SUNDRY NOTICES AND REPORTS ON WELLS
Do not use this form for proposals to drill or to re-enter an abandoned well. Use form 3160-3 (APD) for such proposals.

8. Well Name and No.
RAM EWE FEDERAL 2

Please be advised RKI Exploration requests approval to P&A the above well. The WBD and Plan are attached.

**** BLM REVISED ** BLM REVISED ** BLM REVISED ** BLM REVISED ** BLM REVISED ****

**Ram Ewe Fed #2
Proposed WB**

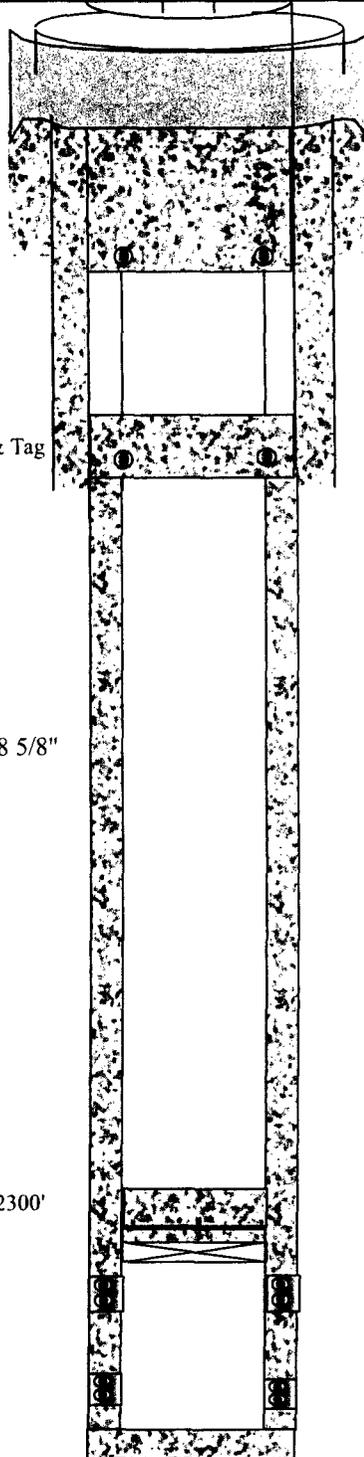
1/2 Delaware 1783

Cherry Cyn 2968
